BY M.J.Bilduc
DATE 2 MAY 06
SIMPSON GUMPERTZ & HEGER INC.
CONSULTING ENGINEERS
41 SEYON ST., BUILDING 1, SUITE 500
WALTHAM, MA 02453
NOVEL IRON WORKS
250 Ocean Road
Greenland, NH 03840
Revisions
No. Date Description
Project Maine Medical Center
Description Anchor Rod SeTTing PLan
Architect TRO
Engineer Simpson Gumpertz & Heger Inc.
Customer WiLLiam Berry & Sons
Holes 13/16(uno) Hold ER70S
AISC Certified Category III
Date: Mar-06
Drawn By J.D
Chk By D.A.D
Job No. 316
Sht. No. AR-1

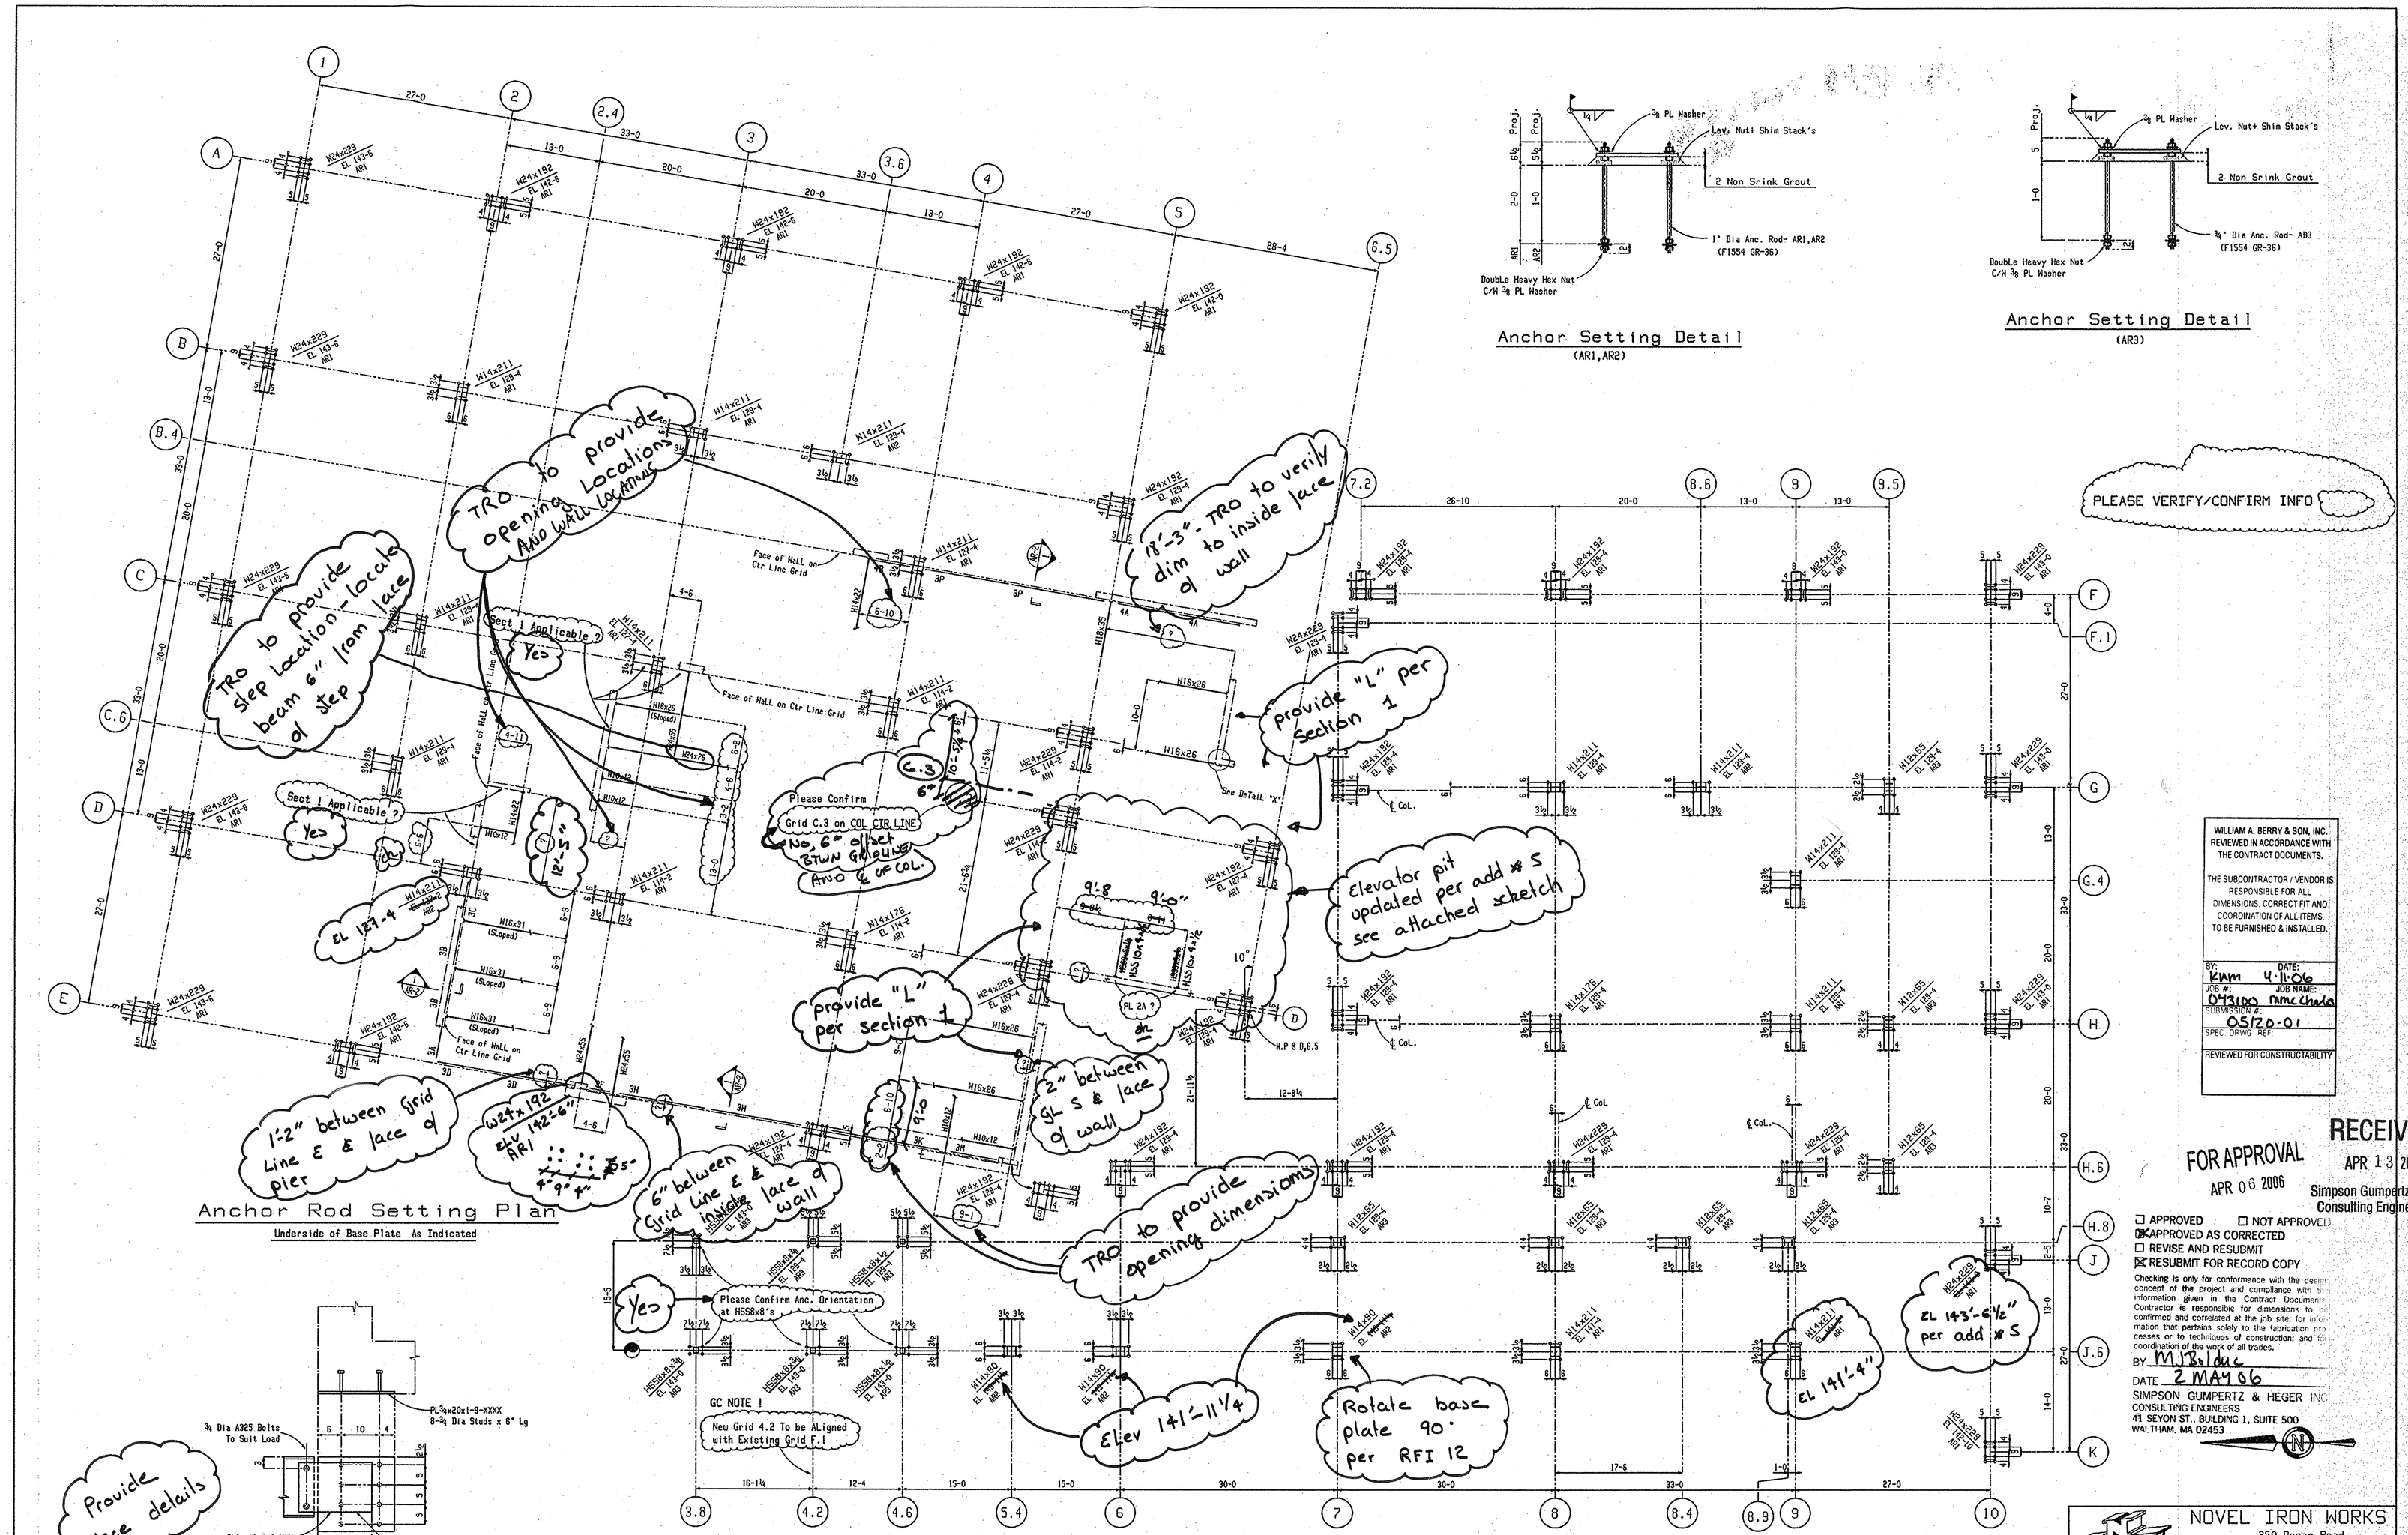
Anchor Setting Detail
(AR1,AR2)
Anchor Setting Detail
(AR3)
Anchor Rod Setting Plan
Underside of Base Plate As Indicated
DeTaiL "X"
PLEASE VERIFY/CONFIRM INFO
TRO to provide opening Location AND WALL LOCATION
TRO to provide step Location - locate beam 6" from face of step
18'-3" - TRO to verify dim to inside face of wall
provide "L" per section 1
Elevator pit updated per add # 5 see attached sketch
provide "L" per section 1
1'-2" between Grid Line ℄ & face of pier
6" between Grid line ℄ & inside face of wall
2" between GL S & face of wall
TRO to provide opening dimensions
Elev 141'-11 1/4
Rotate base plate 90° per RFI 12
EL 141'-4"
EL 143'-6 1/2" per add # 5
Provide piece details
Please Confirm Grid C.3 on COL CTR LINE
No, 6" offset BTWN GRIDLINE AND ℄ OF COL.
Please Confirm Anc. Orientation at HSSBx8's
GC NOTE 1
New Grid 4.2 To be ALigned with Existing Grid F.1
Sect I Applicable ?
Yes
EL 127'-4
Face of WALL on Ctr Line Grid
